Delegated Report		Analysis sheet		Expiry Date:	26/07/2022
(Members Briefing)		N/A		Consultation Expiry Date:	14/08/2022
Officer				Application Numbers	
Obote Hope				2022/2382/P	
Application Address				Drawing Numbers	
55 Princess Road London NW1 8JS				<i>See draft decision notice</i>	
PO 3/4	Area Team Signature	C&UD	Authorised Officer Signature		
Proposal(s)					
Variation of Condition 3 (Approved Plans) of planning permission 2020/5626/P dated 06/05/2021, for the erection of a part one/part two storey rear extension following the demolition of the existing two storey closet wing, and alteration to the front and rear fenestration. Namely, retrospective permission for the erection of 2x dormers on the front roof slope in place of velux windows and removal of portion of rear parapet wall.					
Recommendation:		Refuse planning permission with warning of enforcement action.			
Application Type:		Variation or Removal of Condition

1.1. Retrospective planning permission is sought for variation of Condition 3 (Approved Plans) of planning permission 2020/5626/P (dated 06/05/2021) for the erection of two (2) dormers on the front roof slope of the approved roof extension, installation of t

Fig 2. Proposed dormers as part of current application

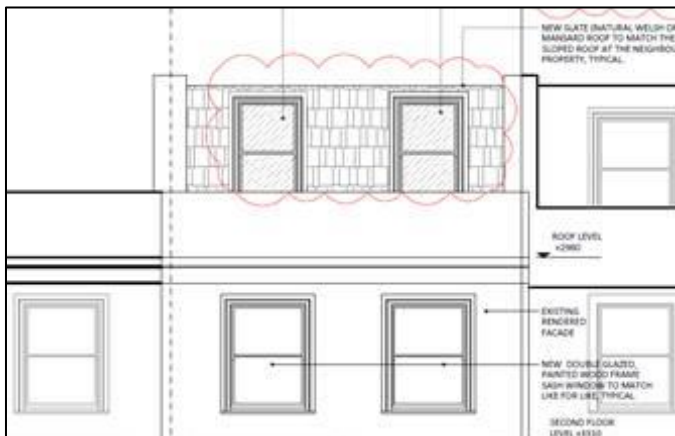
- 3.9. It is noted that the proposed plans submitted as part of the current application (see Figure 2 below) are different than what has been constructed. The proposed dormers show windows of a much larger size, different style, and with narrower dormer cheeks and was actually constructed (see Fig 1 above).

- 3.10. The approved mansard roof extension (ref. 2020/5626/P) measures approximately 2.6m in height, 4.9m in width, and between 4.8 to 5.8m in depth. The as built mansard roof extension measures approximately 2.6m in height, 4.9m in width, and 5.9m to 6.1m in depth. Thus, the increased size and protruding bulk of the dormer roof extension, particularly the dormers, to the front elevation is considered to be out of character with the surrounding street scene and wider Conservation Area.

- 3.11. Typical mansard roof extensions are set back from the front parapet wall to eliminate any perceived bulk, while dormers feature matching window scale and design as well as minimal cheeks to reduce bulk. As a result, the protruding dormers are considered to be highly prominent and incongruous additions which fails to respect the character and appearance of the host property and the wider Conservation Area.
